KITTERY TOWN PLANNING BOARD MEETING

AGENDA for Thursday, September 10, 2015

**UNAPPROVED
AUGUST 20, 2015**

DRAWN GDC/JAA CALC.
 DATE 1 AUGUST 2012
 CHECKED
 APPROVED
 SCALE 1"=50'
 SHEET TITLE:
•GRADING & DRAINAGE PLAN
 SHEET NUMBER:
C3
 SHEET C3 OF C8
 PROJECT # **06-684.02**

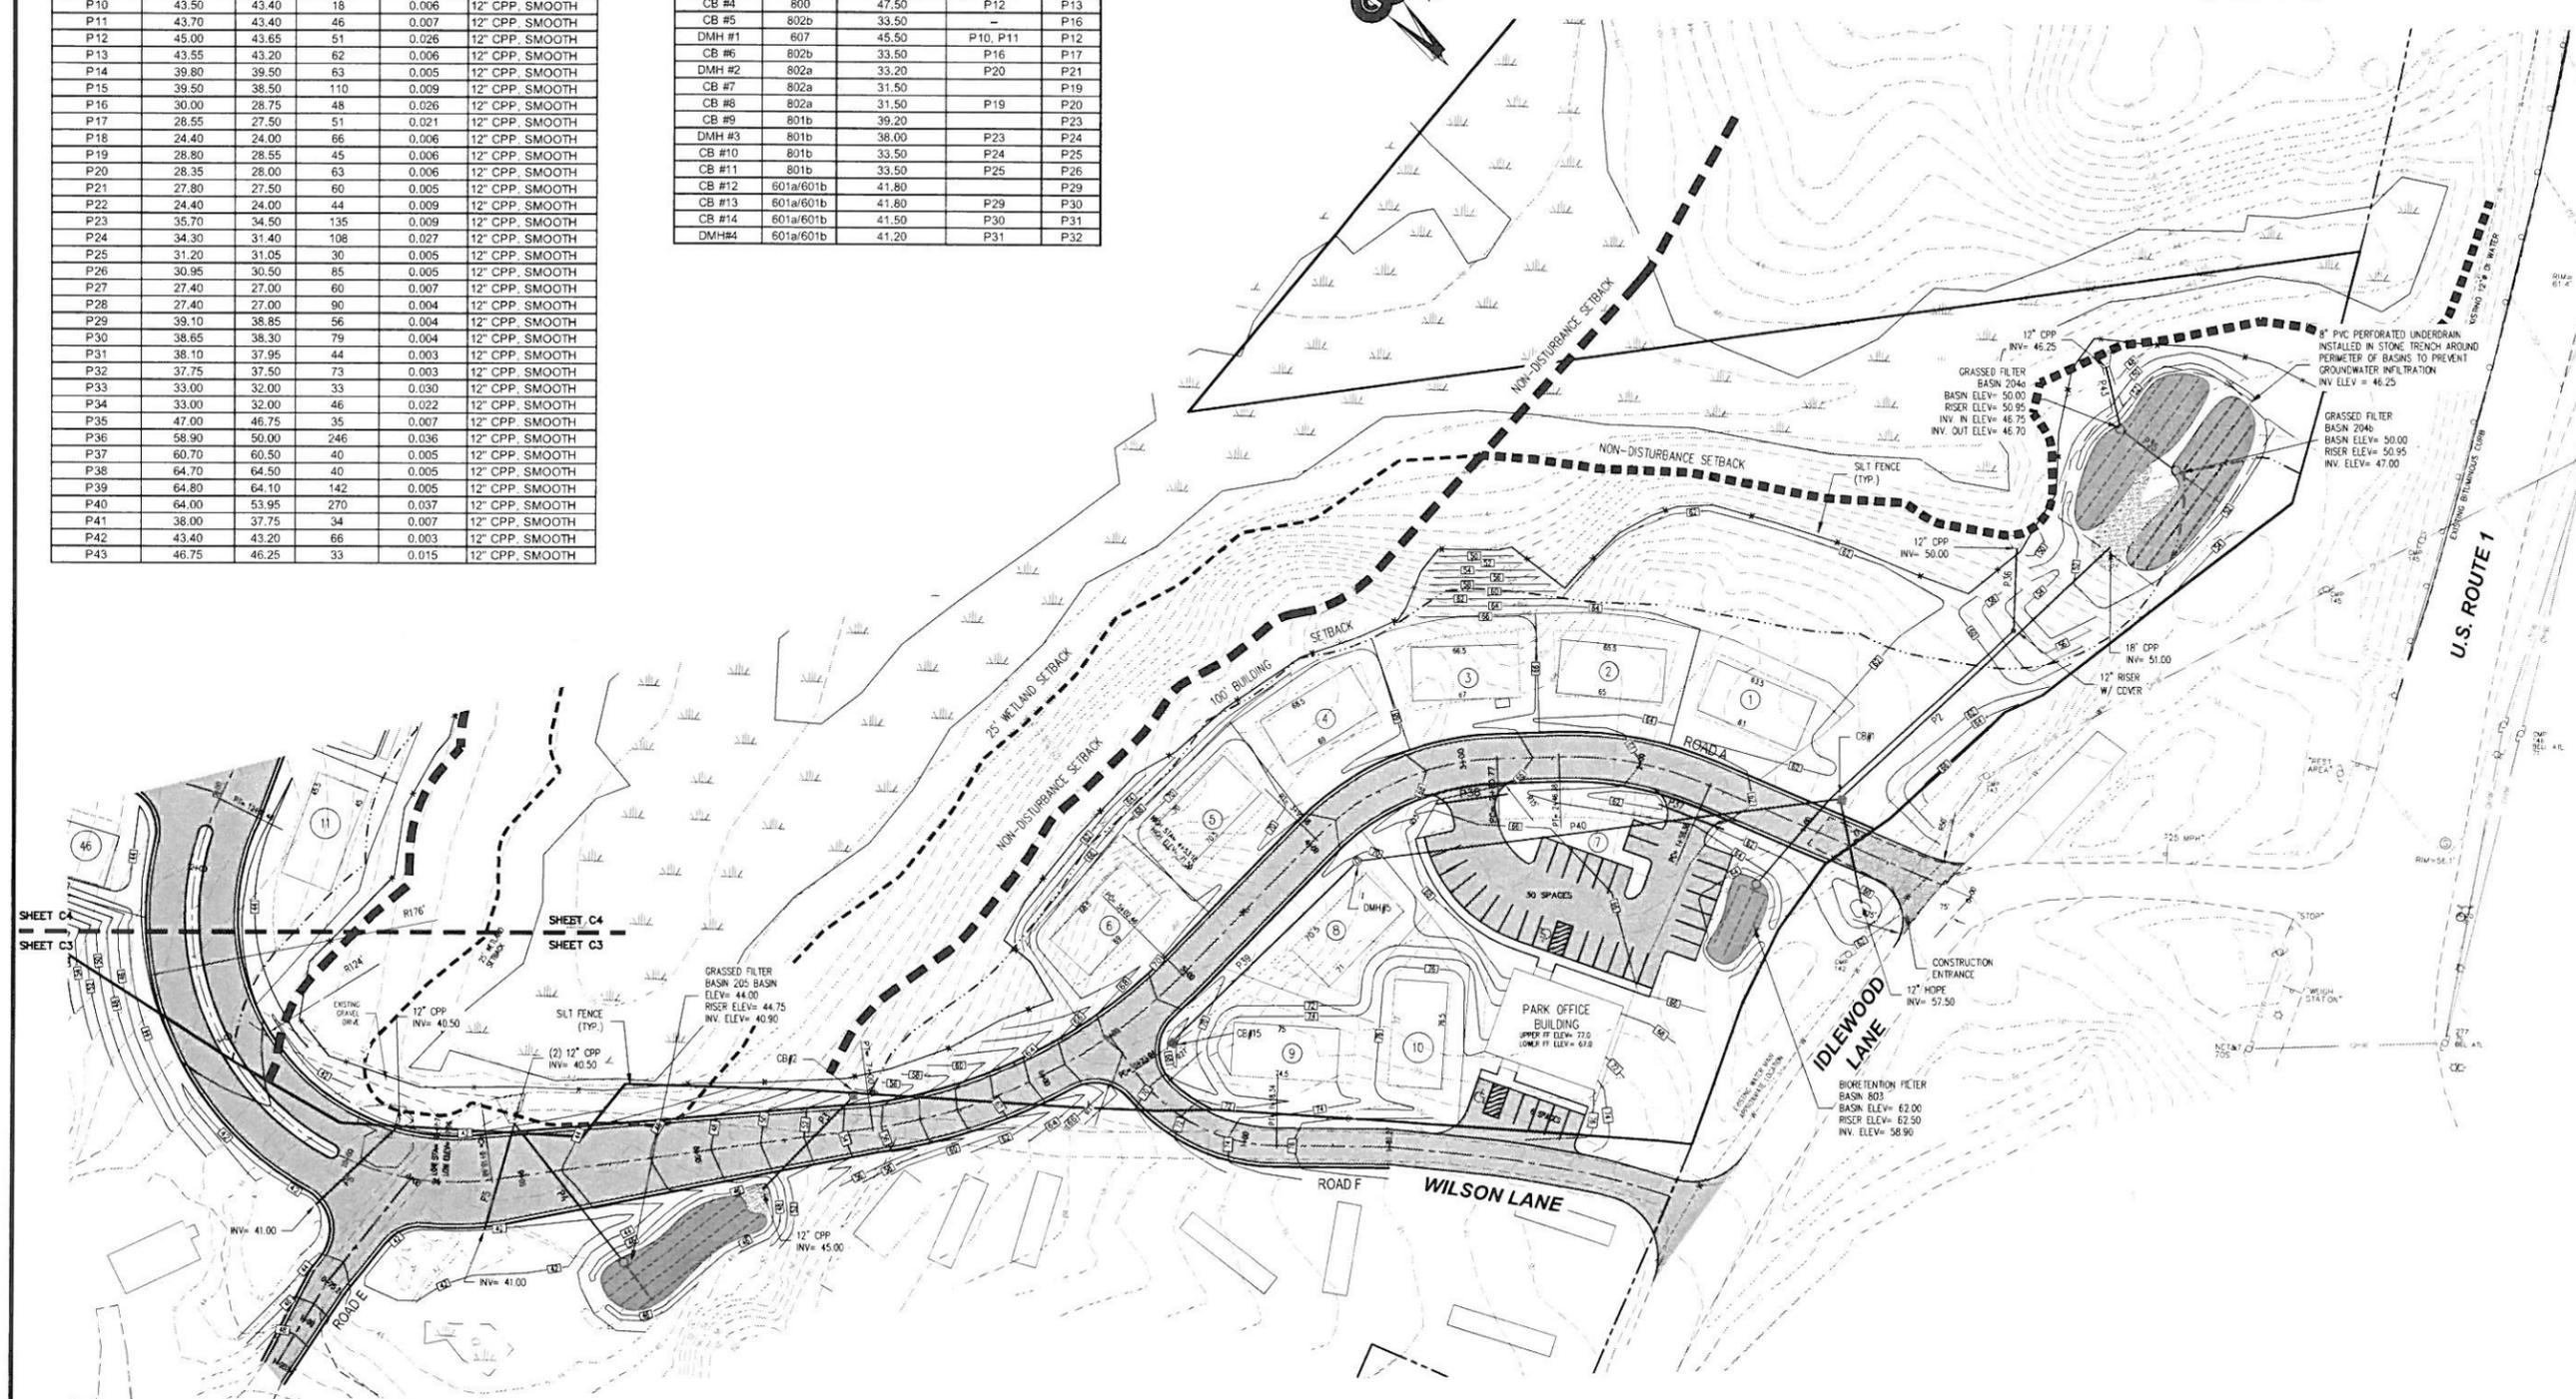
1. Open Space Plan
2. Gorrill-Palmer: TIA_07-22-2015_OPT
- 3a. Vernal Pool Kittery 012
- 3b. Vernal Pool 012 Close-up
4. SW Cole: 15-0640 G - Hydro Review Report
5. Revised Plan Sheet C3 showing modifications to grading adjacent to Idlewood Lane
